**BELL BEND NUCLEAR POWER PLANT  
RESPONSE TO RAIS ENV-28 AND ENV-29  
BNP-2014-022                      Docket No. 52-039**

This letter provides the PPL Bell Bend, LLC (PPL) responses to the Requests for Additional Information (RAI) Nos. ENV-28 (Reference 1) and ENV-29 (Reference 2). The RAIs address information contained in the Bell Bend Nuclear Power Plant (BBNPP) Combined License Application (COLA) Part 3, Environmental Report (ER).

The Enclosure provides PPL's responses to RAI ENV-28, Questions: AE-7314; AE-7324; ALT-7318; HY-7332; NFP-7334; and, RAI ENV-29, Questions HY-7329 and TE-7338

**Figure 2 - Walker Run Bridge, looking downstream**

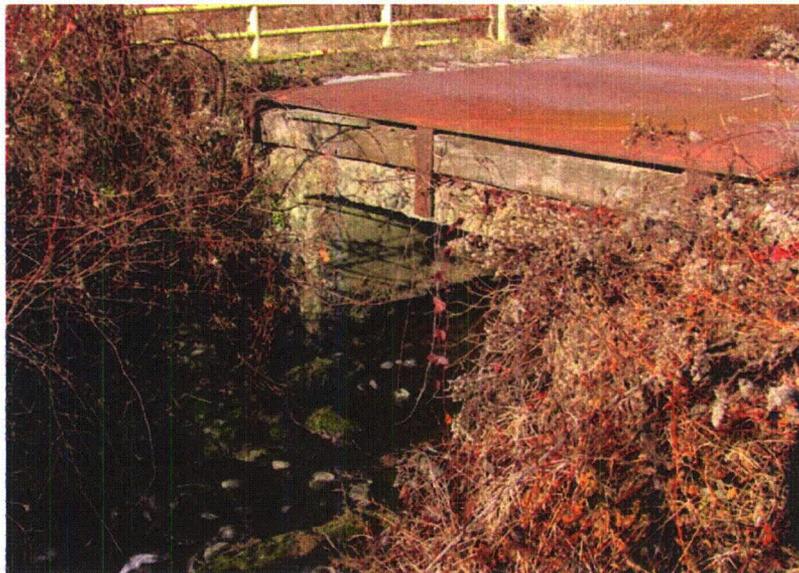
ESRP Section 4.3.2 directs the staff's description, quantification, and assessment of the impacts of construction of the proposed facilities on the aquatic ecosystem. PADEP Water Obstruction and Encroachment Permit, E40-720 (ML13161A023) identifies bridge removal as an impact associated with Joint Permit Application (JPA) Impacts A (Walker Run) and B (Unnamed Tributary 1). The JPA and ER Rev 4 do not describe the bridge removal process and the associated potential impacts. Describe the bridge removal process associated with JPA Impacts A (Walker Run) and B (Unnamed Tributary 1). Characterize the potential impacts to aquatic resources from the bridge removal and describe any steps that would be taken to minimize those impacts.

The bridge over Walker Run consists of three sections (refer to attached Figures 1 through 3). The lower section is a 10-foot long, 12-foot wide concrete arch spanning Walker Run. The top flat part of the arch is covered by a middle section consisting of 15 railroad ties laying side-by-side. Each tie is 13 feet in length, 9 inches wide and 7 inches in height. The two end sections of each tie are embedded in the top part of the stream bank. The railroad ties are covered by two 1/2-inch steel plates tack welded together at the center seam. Each plate measures 10 feet in length and is 6 feet wide. The top of the bridge measures approximately 10 feet in length and 12 feet wide. There are three vertical straps welded to each plate's side to prevent the top plate from shifting from side-to-side. The top of the bridge is about 5 feet from the bottom of the stream at low level. The bridge will be removed by a machine such as a back hoe.

The removal of the Walker Run Bridge will occur during construction of the Walker Run mitigation project. Walker Run will remain in the existing stream channel while the restored channel is being constructed under dry conditions. Following new channel construction and the installation of appropriate stabilization measures, as described in the Walker Run Mitigation Plans dated August 12, 2011 included in the Walker Run Design Report Rev 0 (JPA Rev.1 Mitigation Section), the flow will be directed from the existing channel into the new, restored channel. At this point the bridge will be removed. Since the channel will already be abandoned at the time of the bridge removal, there will not be any impacts to the watercourse resulting from bridge removal.

**Exploded view of ER Figure 2.3-93 Groundwater Well Locations within a 5-Mile (8-km) Radius**

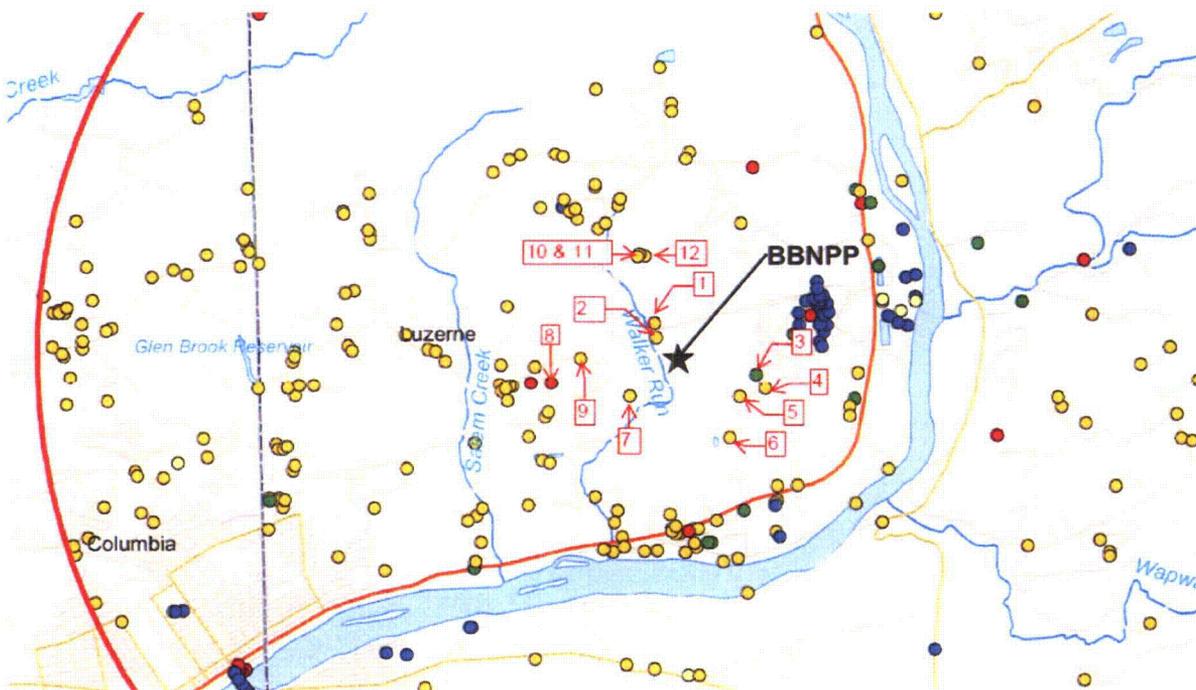
ESRP Section 2.3.2 directs the staff's description of surface water and groundwater uses and users that could be affected by the proposed project. For groundwater uses, this description includes locations and depths of the wells, identification of the aquifers from which water is withdrawn, and the average withdrawal rates. For surface water, non-consumptive water uses must be included in the description. The ER does not adequately describe water uses for nearby wells and surface water bodies. Provide groundwater use information for the wells located within approximately one mile of the BBNPP site, as shown in ER Figure 2.3-93, including the domestic well shown located near the pond on the property to the south of the site. Identify any non-consumptive uses for the surface water bodies located on the property to the south of the BBNPP site.

There are twelve (12) wells located within an approximate 1-mile radius from the Bell Bend Nuclear Power Plant (BBNPP) reactor centerline illustrated on Figure 2.3-93, "Groundwater Well Locations within a 5-Mile (8-km) Radius" of the BBNPP Combined License Application (COLA) Part 3, "Environmental Report" (ER). These wells are identified on the attached exploded view of ER Figure 2.3-93, below. Information for these wells are in the table, "Well Information within Approximately 1-Mile Radius," below.

ER Section 2.3.1.2, "Groundwater Resources" discusses the three aquifers located at the BBNPP site and ER Figure 2.3-36, "Thickness Map of the Glacial Overburden Aquifer" provides a thickness profile of the glacial outwash thickness. Based on this information, the two shallow wells (#3 and #5) are most likely in the Glacial Outwash Aquifer. ER Section 2.3.1.2.3.1, "Site

Hydrogeology” places the division between the Shallow Bedrock and Deep Bedrock aquifers at approximately 175 feet. Therefore, all the other wells, except for Well # 8, are most likely located in the Shallow Bedrock aquifer. Well #8, at a depth of 380 feet, is most likely located in the Deep Bedrock aquifer.

Annotated FSAR Figure 2.4-47, "Surficial Deposits in the BBNPP Site and Vicinity"

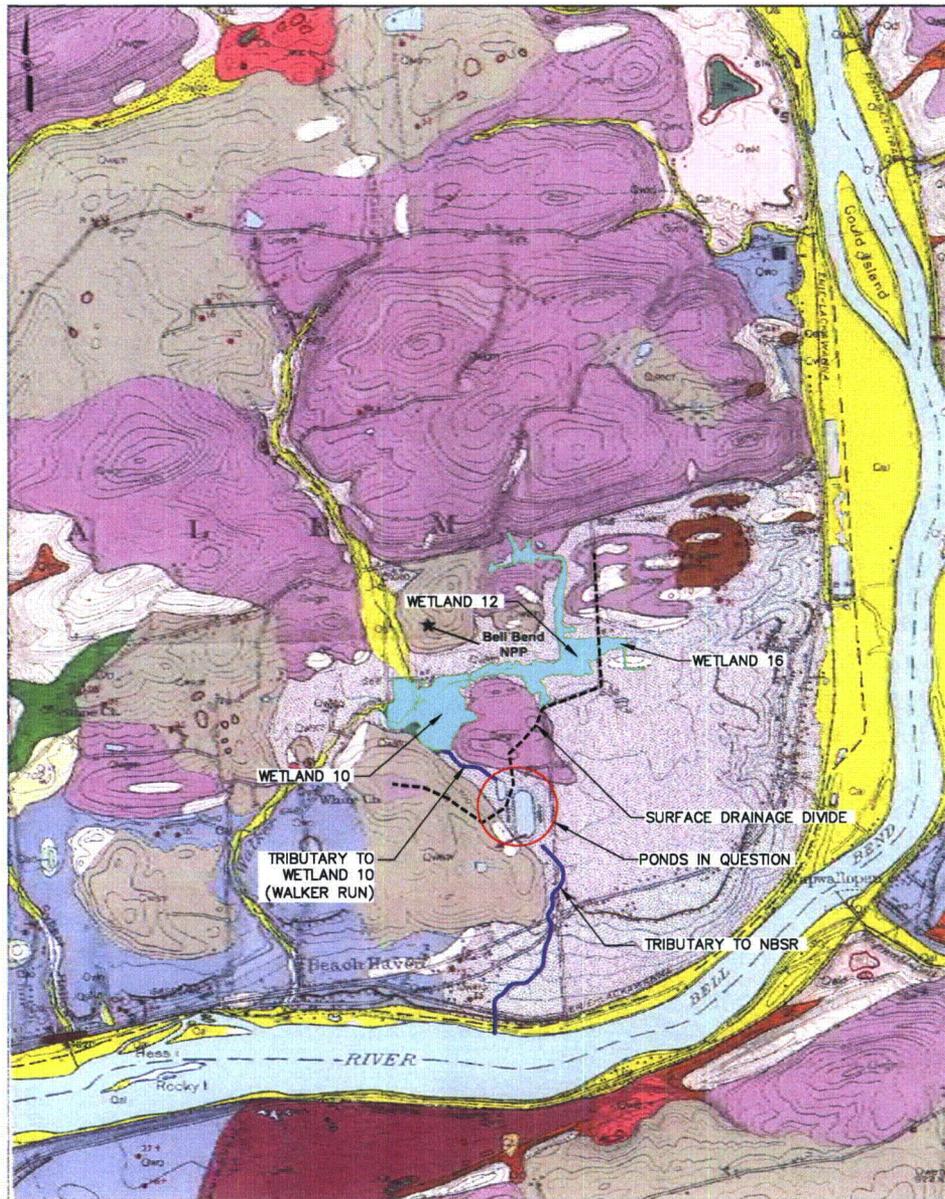
ESRP Section 2.3.1 directs the staff's description of the hydrology of the proposed plant site and the surrounding area that could be affected by construction activities and plant operation. This description includes interactions between surface water and groundwater. The ER does not adequately describe the water resources located on the property to the south of the BBNPP site. Identify the source(s) of water for the surface water bodies shown in ER Figure 2.3-3 on the property to the south of the BBNPP site. These features include the oval-shaped pond and the adjacent, smaller pond to the northwest, the stream between this smaller pond and the wetlands near the confluence of Unnamed Tributary 1 and Walker Run, and Unnamed Tributary 3. Describe the interactions between these surface water bodies and between these surface water bodies and the groundwater.

These surface water bodies shown in the Bell Bend Nuclear Power Plant (BBNPP) Combined License Application (COLA) Part 3, Environmental Report (ER) Figure 2.3-3 "Walker Run Watershed" occur along the surface drainage divide. The location of the ponds Wetlands 12 and 16; the surface drainage divide; and other surface drainage features, are shown on the attached annotated Final Safety Analysis Report (FSAR) Figure 2.4-47, "Surficial Deposits in the BBNPP Site and Vicinity" illustrating the surficial geologic formations in the vicinity of the BBNPP site. The oval pond is in the center of an old motorcycle racetrack, so the pond configuration and surface hydrology has been historically manipulated to provide drainage for the racetrack into the pond. The oval pond drains to an unnamed tributary to the North Branch of the Susquehanna River, originating from the southeast corner of the pond and flowing south to the river. The smaller pond drains to a stream/wetland system flowing northwest to Wetland 10 on the Bell Bend site, and ultimately to Walker Run. Despite the presence of the surface drainage divide, it is highly likely that there is a subsurface groundwater connection between the two ponds. The ponds are situated in the same glacial overburden deposits as Wetlands 12 and 16, which are located on the Bell Bend site farther north adjacent to Confers Lane. Confers Lane has been identified as the surface drainage divide between these two wetlands, but a subsurface groundwater connection has also been determined. The oval pond and smaller pond in question are in a similar landscape position and in the same geologic formation as Wetlands 12 and 16, and appear to have a similar groundwater connection. There is some visual evidence from aerial photographs that there may be a pipe connection between the two ponds from the northwest corner of the oval pond to eastern side of the smaller pond, but this has not been field verified. Note that this evaluation is based on available aerial imagery, geologic mapping, and a general understanding of the local geologic and hydrologic conditions and patterns. Field investigations have not been conducted on this site, as it is outside of Bell Bend or other PPL-owned property.
